MultiCare
EMERGENCY DEPARTMENT & CANCER CENTER EXPANSION
TACOMA, WASHINGTON

CCD 04 (RFI 0314)	12-17-08
CCD 04	12-17-08

**1ST FLOOR
PLAN - NORTH -
MEDICAL GAS PIPING**

**M3
11**

1ST FLOOR PLAN - NORTH - MEDICAL GAS PIPING
SCALE: 1/8"=1'-0"

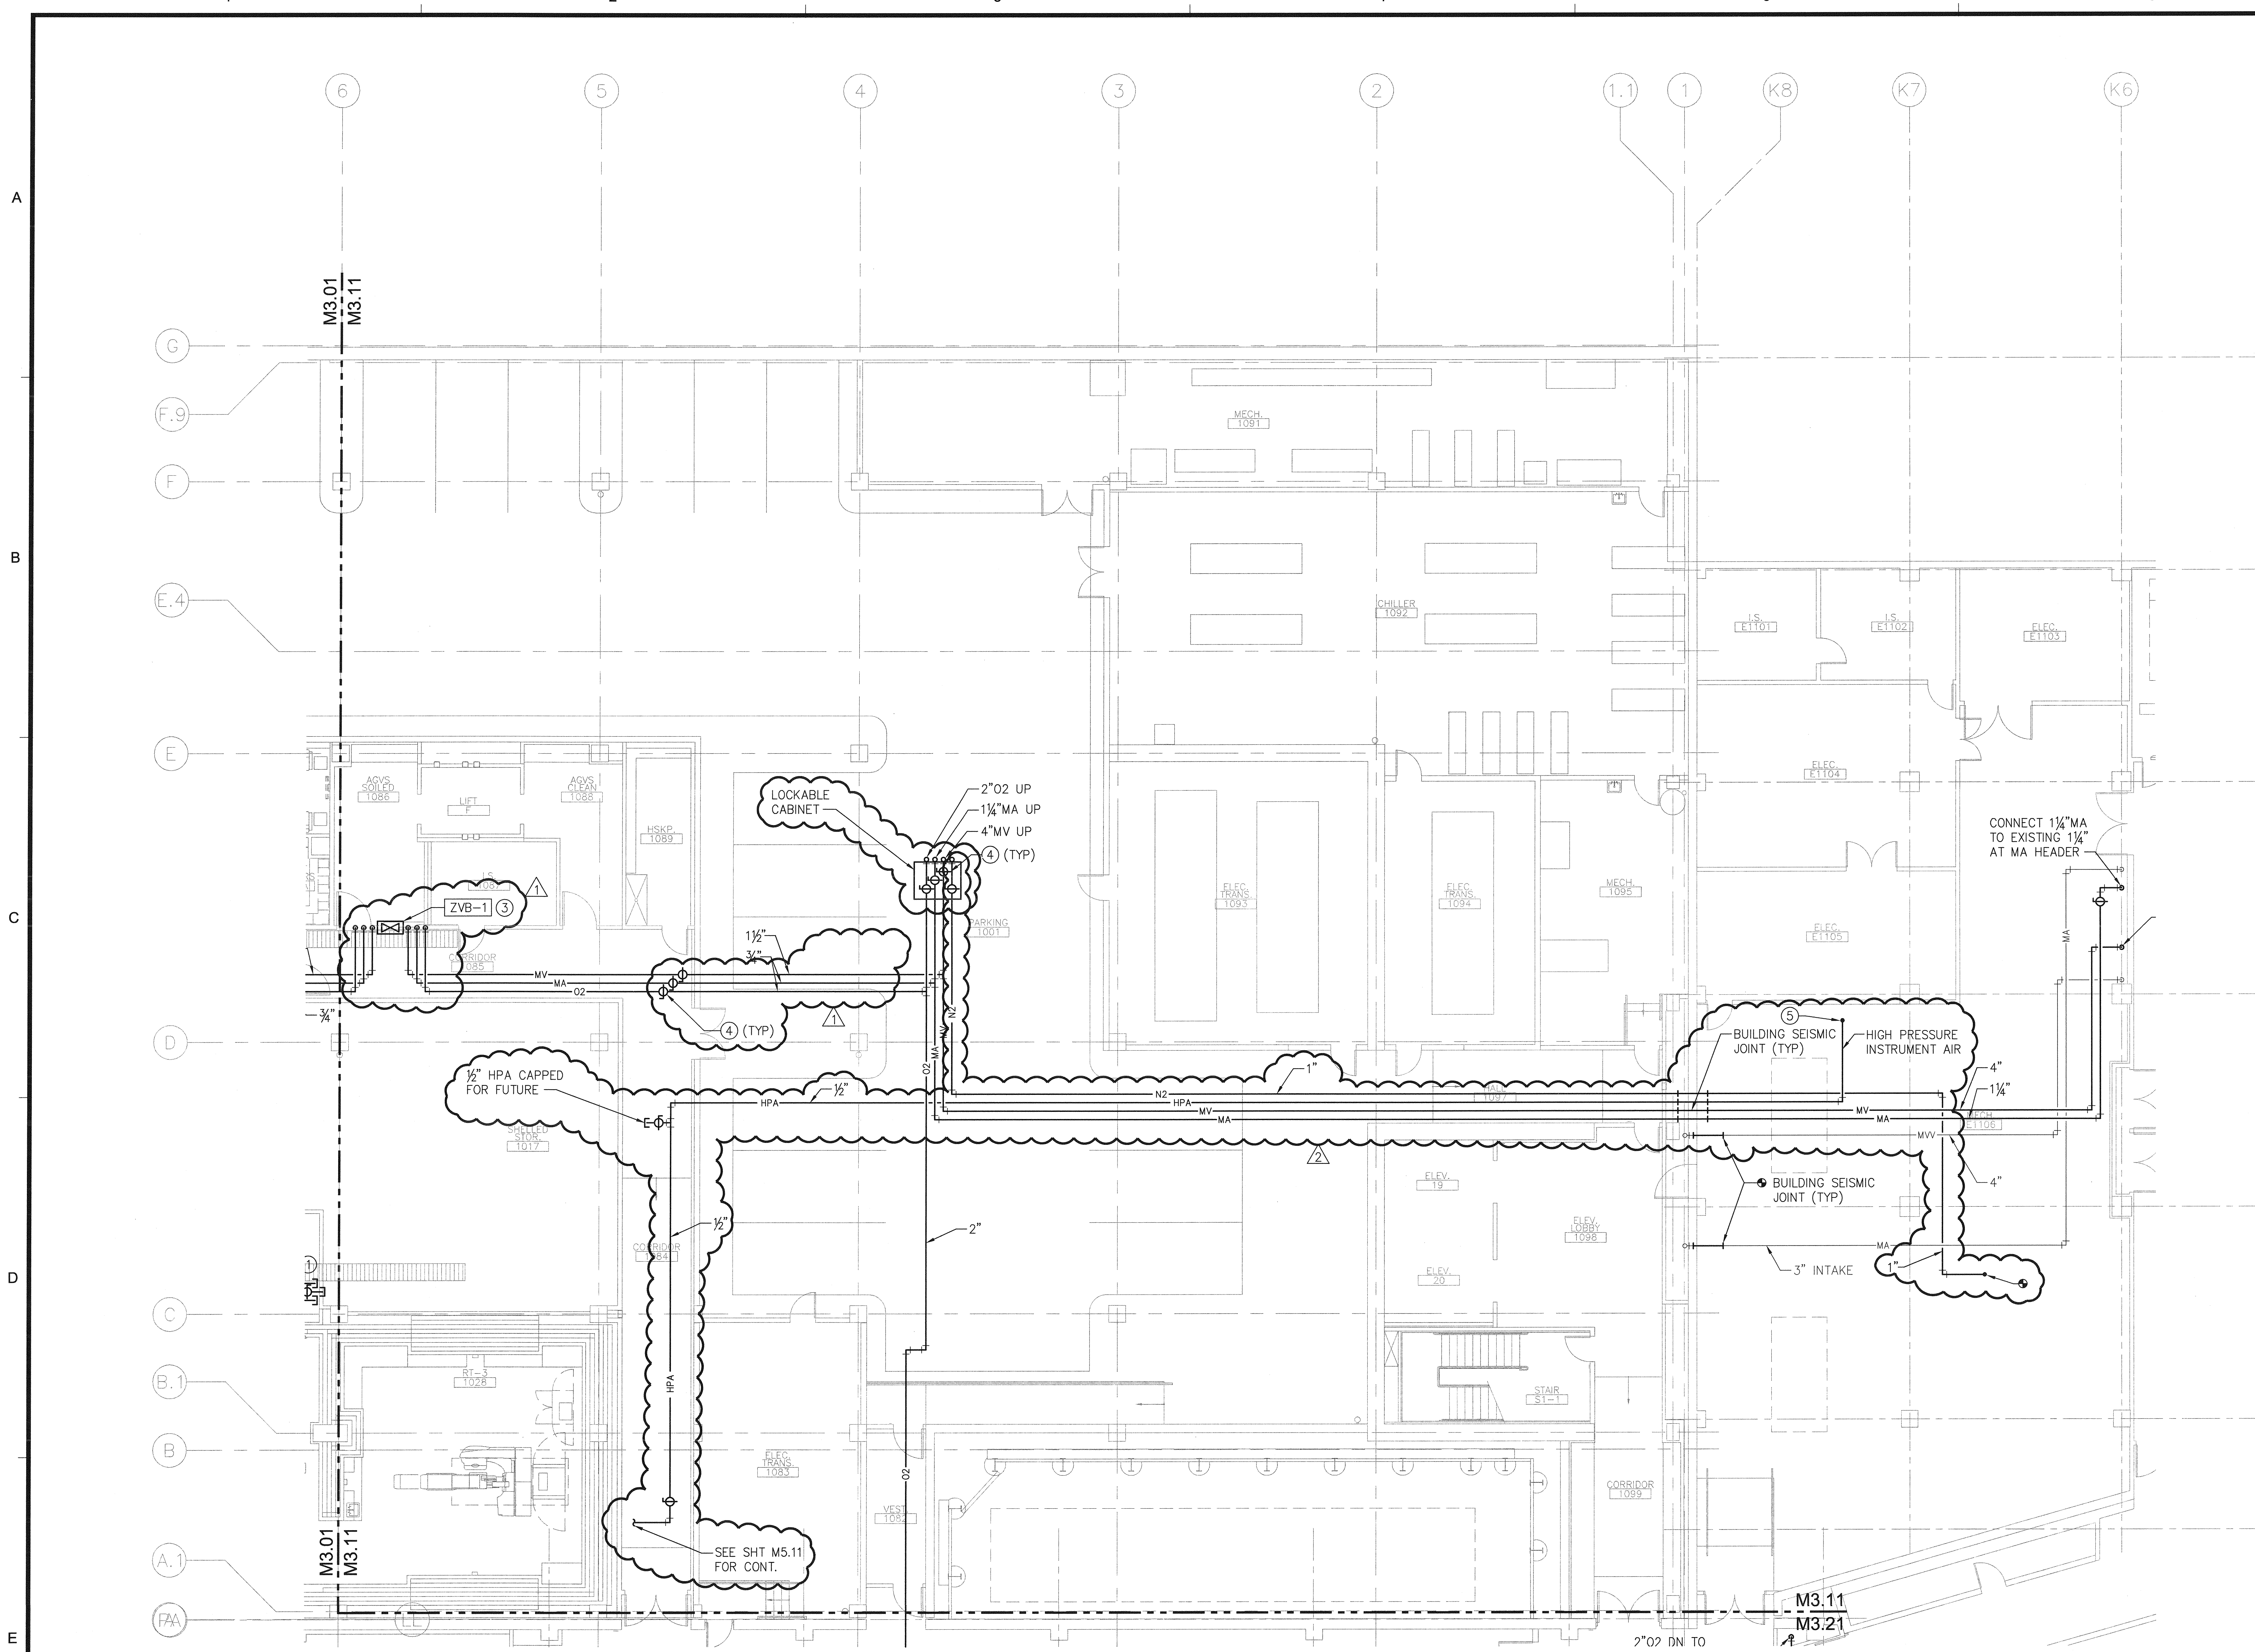
- KEY NOTES:**
- ① 2"O2 TO L-WING MEZZANINE. CONNECT TO EXISTING 4"O2 STUB. PROVIDE 3" VALVE AND CAP FOR FUTURE NEAR TIE-IN.
 - ② EXTEND EXISTING 4"MV HEADER AND PROVIDE 4"MV BRANCH WITH ISOLATION FOR ED.
 - ③ MEDICAL GAS AREA ZONE VALVES.
 - ④ SERVICE VALVES LOCKED OPEN.
 - ⑤ CONNECT 1/2" HIGH PRESSURE INSTRUMENT AIR DOWNSTREAM OF DRYER. PROVIDE AN OIL FILTER AND PRESSURE REGULATOR ABOVE EXISTING HPA MANIFOLD. REGULATE AIR PRESSURE TO 70 PSIG.
